Report: Commissioning

Shake Shack (Chesterfield) - Commissioning

Project: Shake Shack (Chesterfield) - Commissioning

Diffusernoted.jpeg

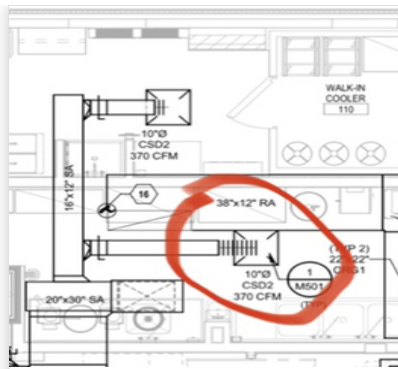
Branch dampers are installed and accessible

Diffuser takeoff moved to top and routed around obstructions. Best possible path due to obstructions. If TAB is not able to access damper during balance, MC will have to secure the take off damper to 100% open and mount a new damper at the diffuser neck. During inspection C-Agent was able to get to damper on 8ft ladder (prior to ceiling grid)

Branchsrandartakeoff.jpeg

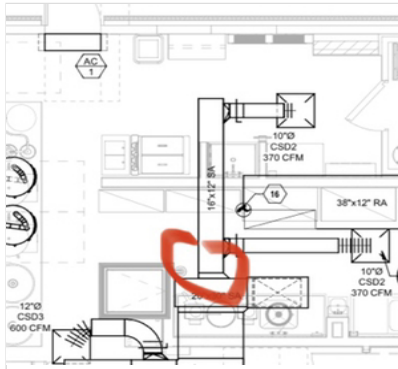
High efficient take-offs are installed for each branch line

Most take-offs are high efficient, a few areas noted have straight round take-offs. If flow is not achieved during balance, MC should scoop or change the take-off. Due to the location C-agent does not believe this take-off will present an issue.

Offsetnotondrawing.jpeg

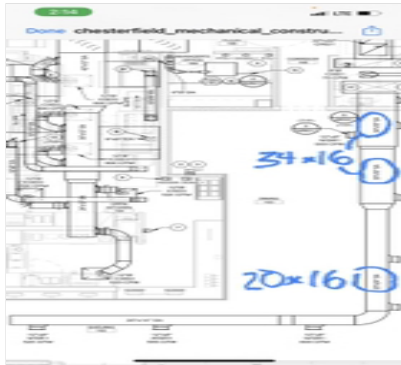
Through wall offset was installed due to arch/mech drawing location difference. Offset created to avoid conflicts with lighting

Halfinchthreadrod.jpeg

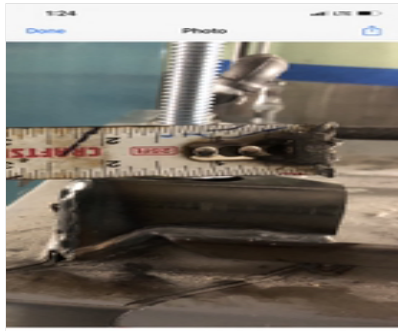
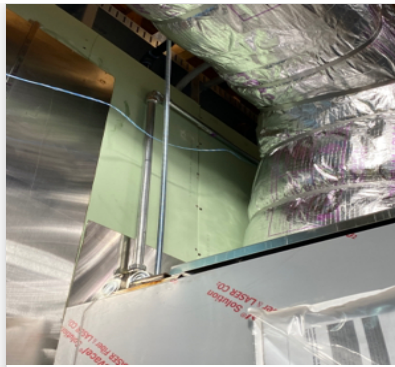
Hood is hung using 1/2" all-thread and supported from beam clamps or uni-strut off from the building structure	3/8" originally installed. MC replaced with 1/2" rod
--	--

Cleanouts.jpeg

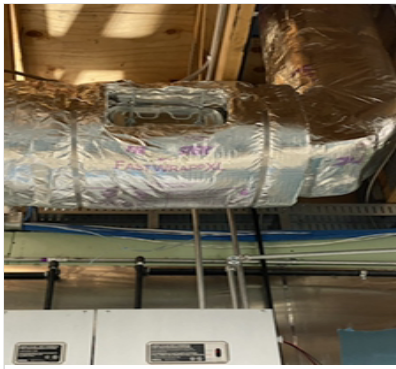
Cleanouts fire wrapped and marked for easy verification and access	Installed but cleanouts not insulated and marked at time of inspection,
--	---

FuseIT40d7b91d085c4e.jpeg

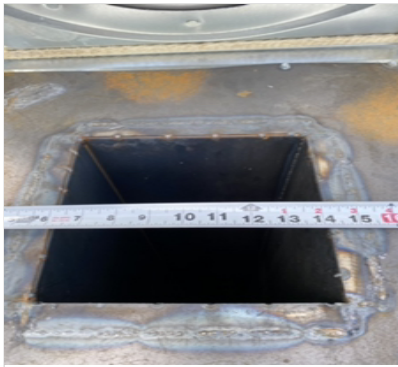
Duct is flashed to top of curb, flat so that the perimeter gasket can seal the top plate air tight

Curb is flashed but it is not flush, mechanical needs to unscrew the top plate and flatten the curb plate to obtain a good fan seal before securing to the curb

**FuseIT87dd1512d8e24ca3b81
8af86903b9e4f.jpeg**

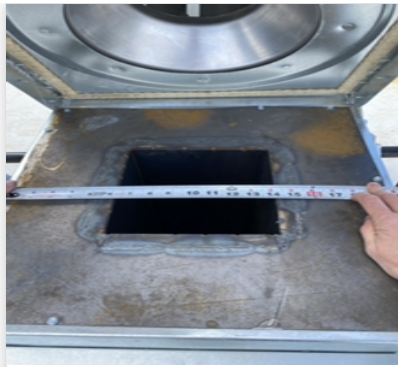
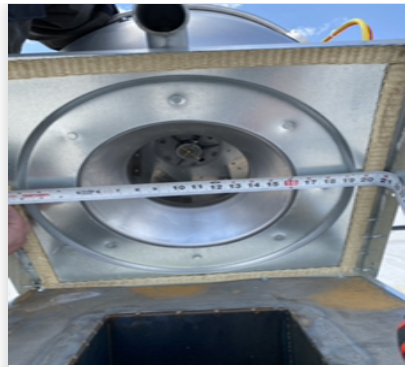
Grease duct is located in the center of the curb top plate so that the fan's inlet venturi is centered within the grease duct

Grease duct is located in the center of the top plate, duct does not transition out to surround the fan inlet.
